DEVIATION REQUEST (Attach diagrams, figures, and other documentation to clarify request)

A deviation from the standards of or in Section **ECM section 2.3.2 Design Standards** of the Engineering Criteria Manual (ECM) is requested for the Homestead North Intersection Spacing.

HOMESTEAD NORTH

EXHIBIT A

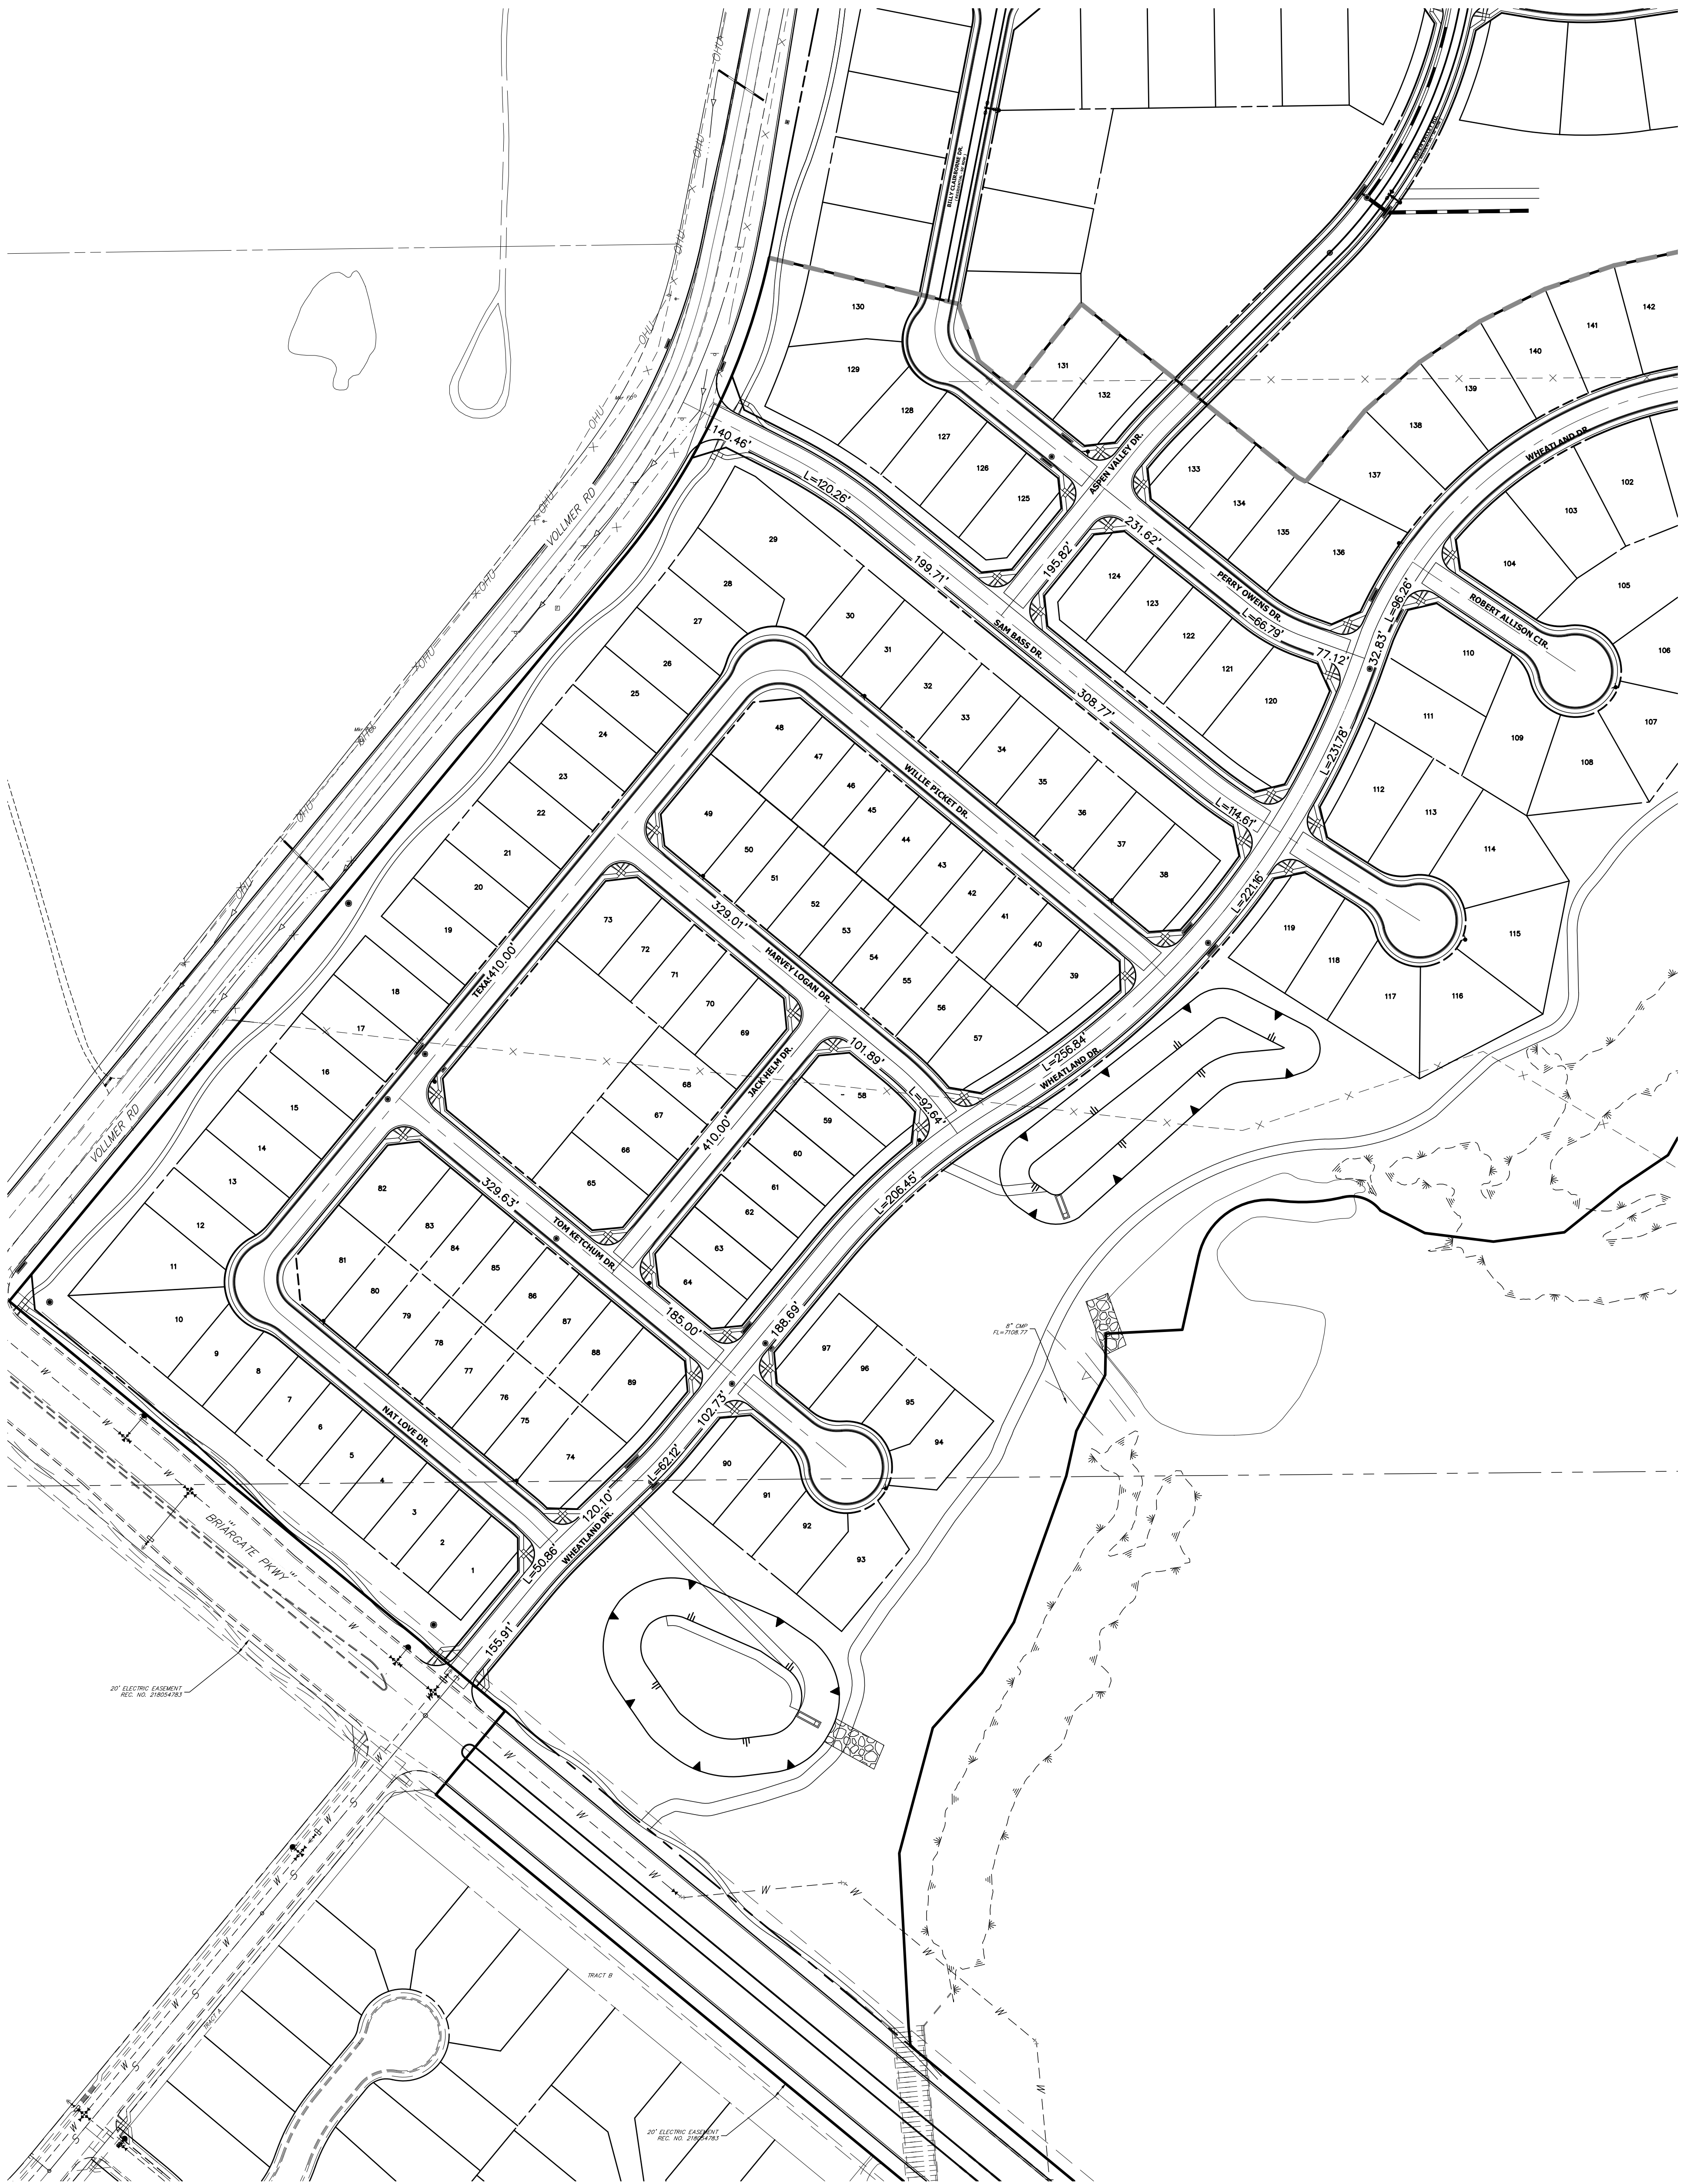
The intersection spacing along Wheatland Drive between Perry Owens Dr. and Robert Allison Cir. is 129.1 feet .

See Exhibit A for a sketch of the preliminary plan and intersection spacing.

Robert Allison Circle is a short Cul-de-sac serving 5 lots. Robert Allison Circle was placed in this align to provide an effect lot layout that is harmonious to the topography and nearby creek.

Robert Allison Circle and Wheatland Drive north of Robert Allison Circle is classified as a "Local Low Volume" roadway.

The TIS study prepared by LSC reflects this alignment and notes no concerns with the intersection spacing given the low ADT volumes in the area.

Robert Allison Circle is designed to drain stormwater back to Wheatland. To place the cul-de-sac farther north would change the alignment and likely force the cul-de-sac to drain towards the east and Sand Creek and would require significant storm piping to route the stormwater flows along the creek open space and into the proposed detention pond to the south. Sanitary piping would also have to be excessively deep to serve the downsloping lots on the cul-de-sac.
